**Re: TransPort Colorado – FDP SubArea #1 (Tab #5)  
Response to 4<sup>th</sup> Comments for 5<sup>th</sup> Submittal (Technical)**

# TransPort Colorado Logistics & Commerce Park Sub-Area 1 Open Space, Circulation & Neighborhood Plan Tab #9

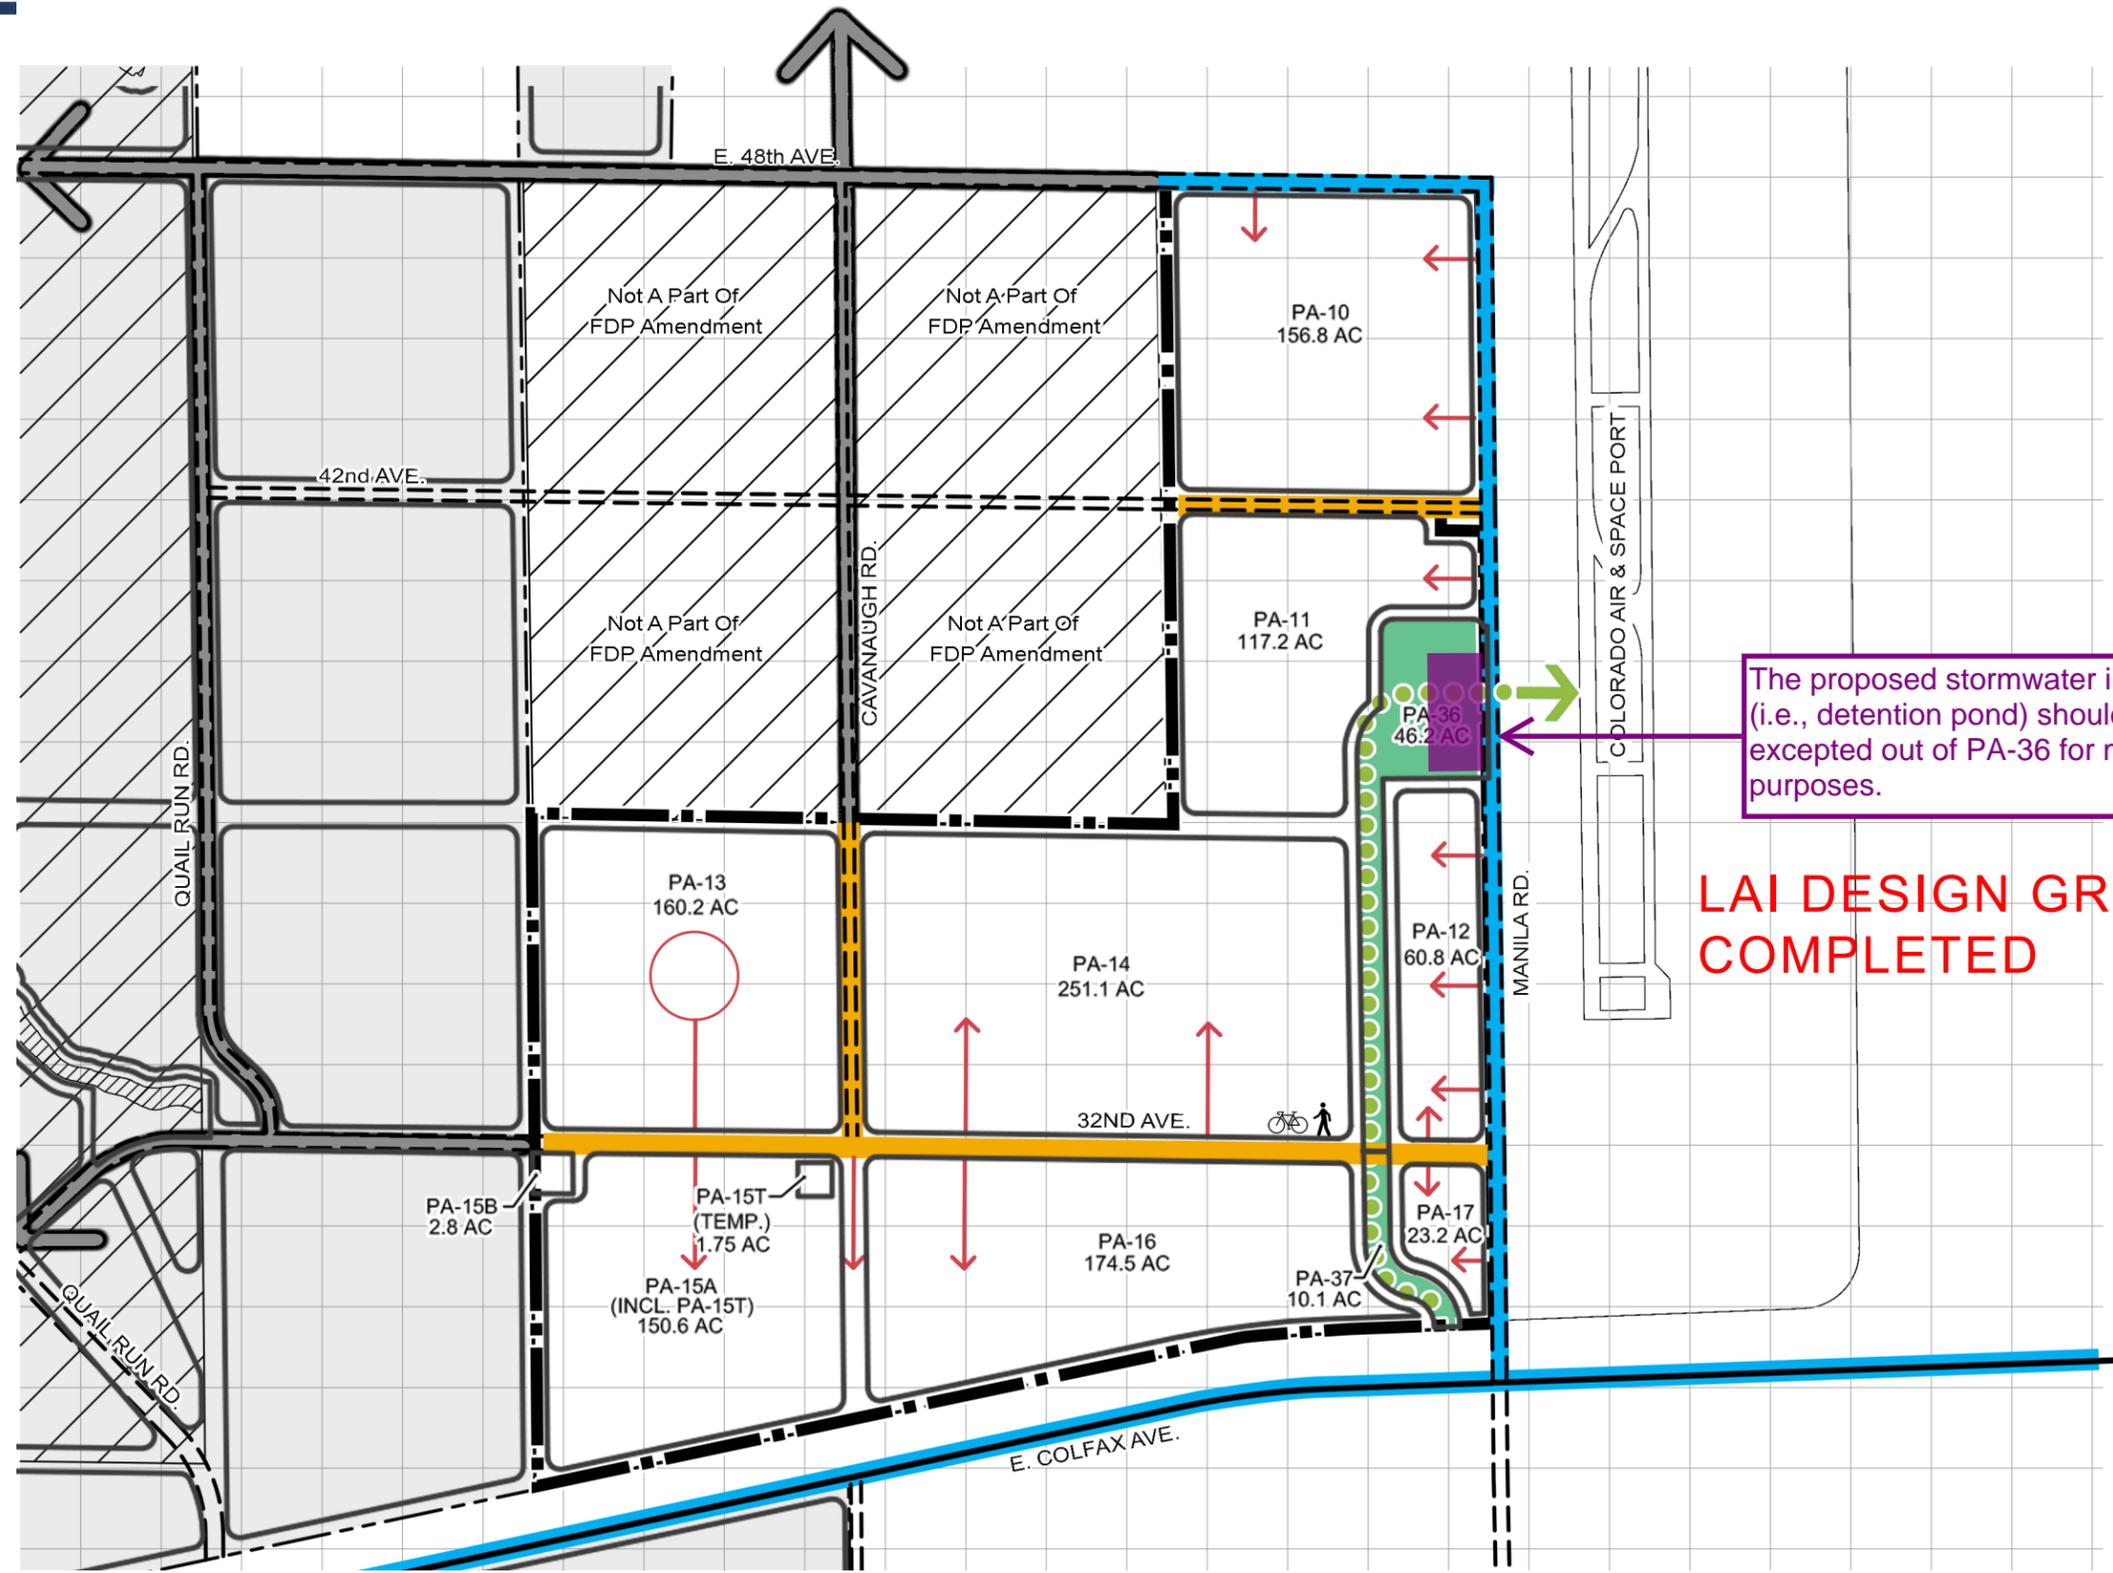
The proposed stormwater infrastructure (i.e., detention pond) should be excepted out of PA-36 for mapping purposes.

**LAI DESIGN GROUP:  
COMPLETED**

# TransPort Colorado Logistics & Commerce Park Sub-Area 1 Open Space, Circulation & Neighborhood Plan

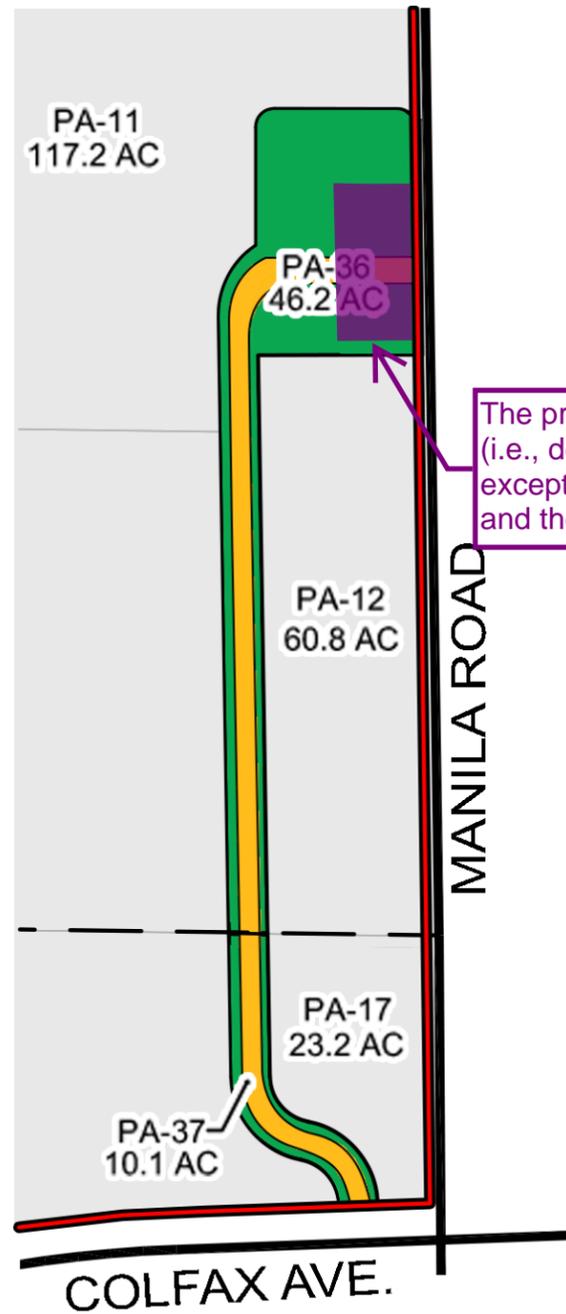
The proposed stormwater infrastructure (i.e., detention pond) should be excepted out of PA-36 for both the maps and the acreage calculations.

**LAI DESIGN GROUP:  
COMPLETED**

# TransPort Colorado Logistics & Commerce Park Sub-Area 1 Public Improvement Plan Tab #13

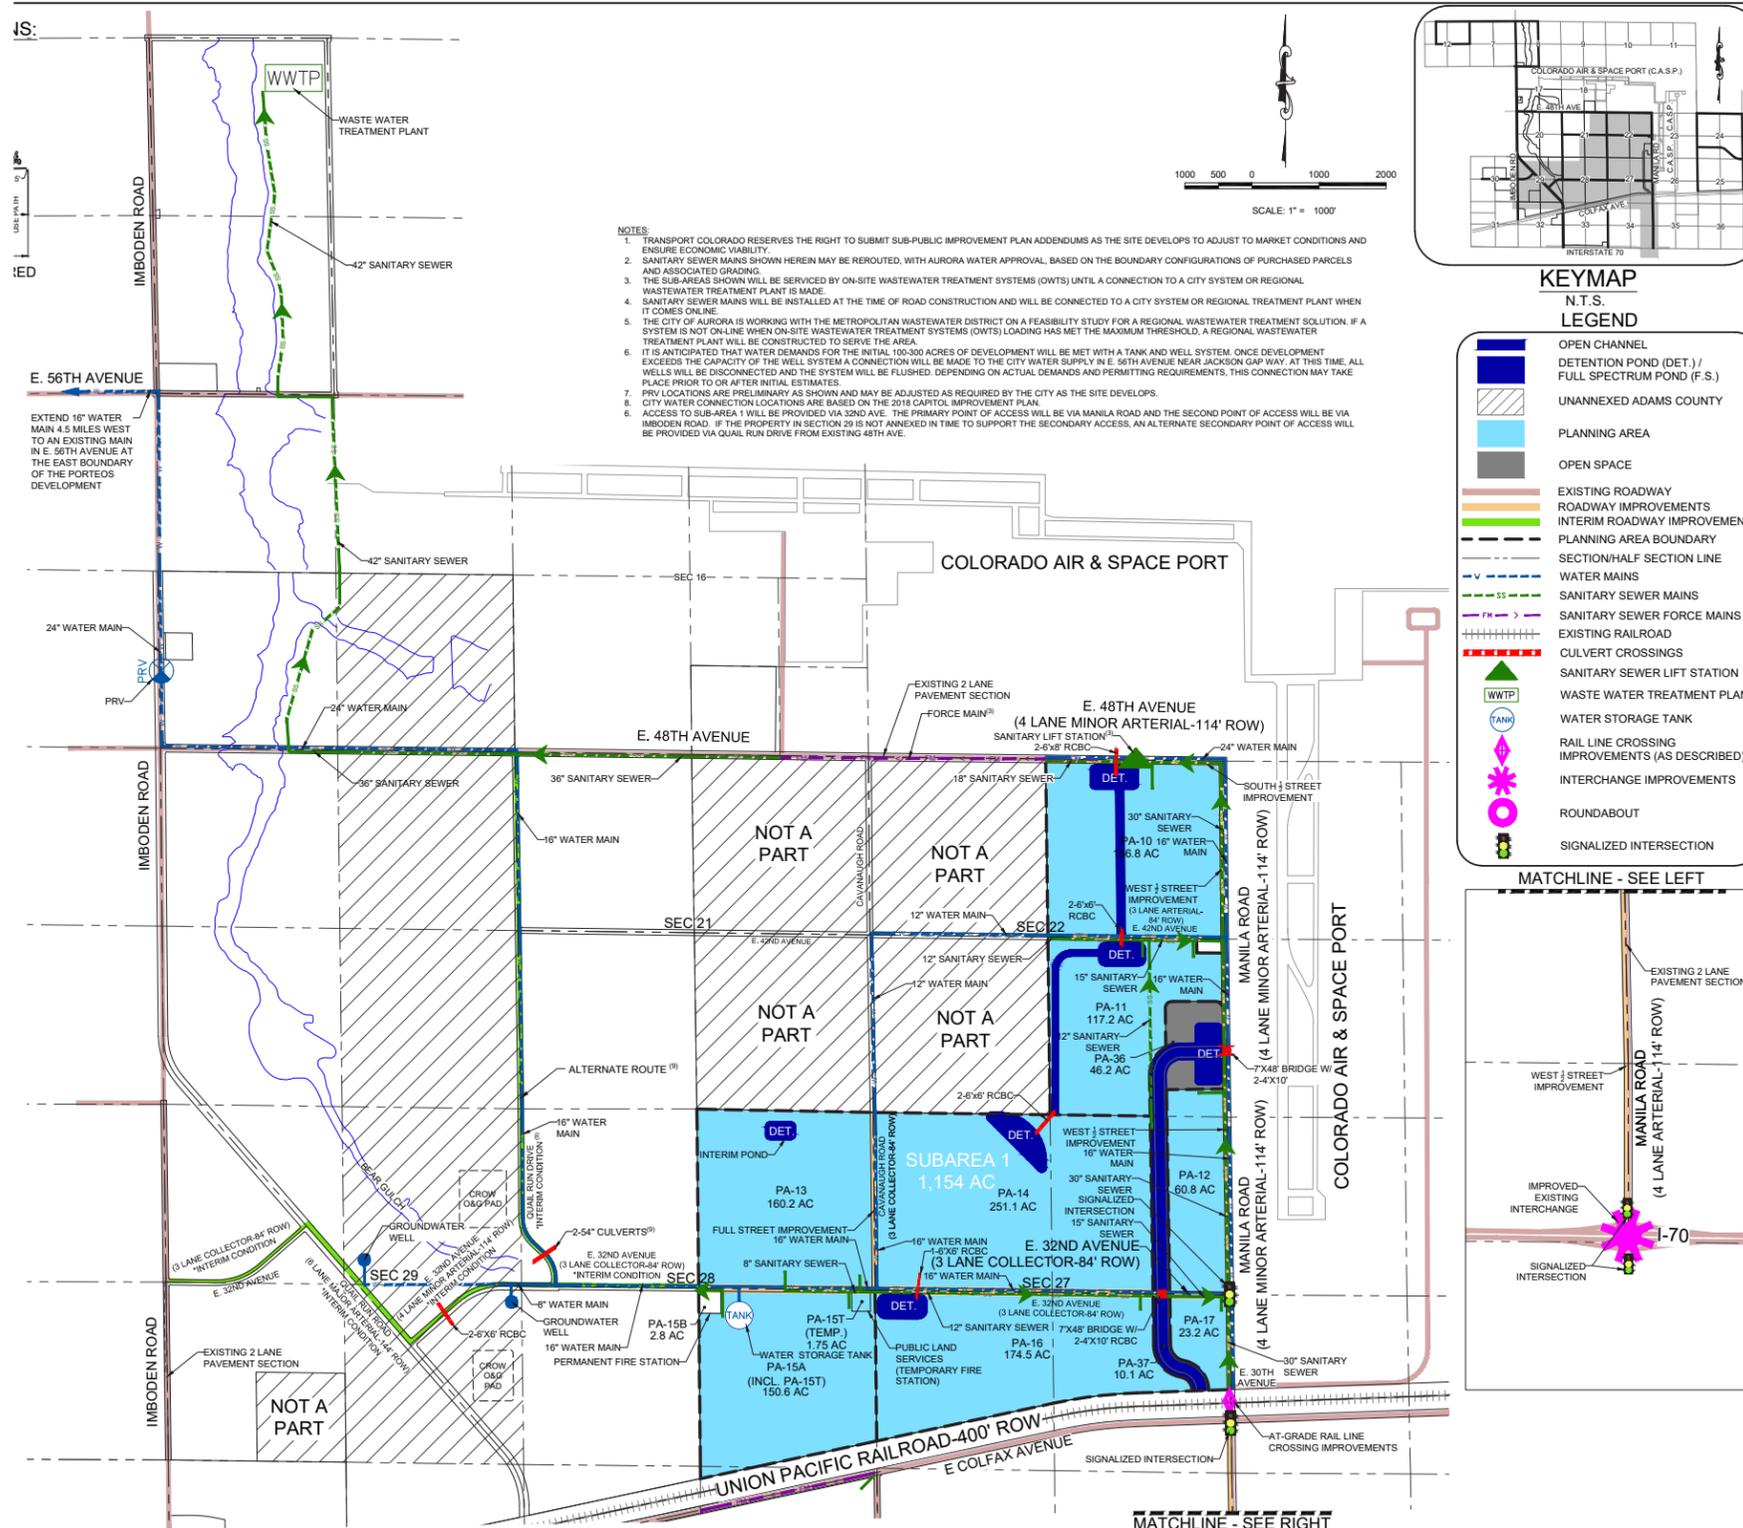
The narrative and the exhibits is Tab 13. There is no need for a separate document

Combine into the PIP narrative

LAI DESIGN GROUP:  
COMPLETED
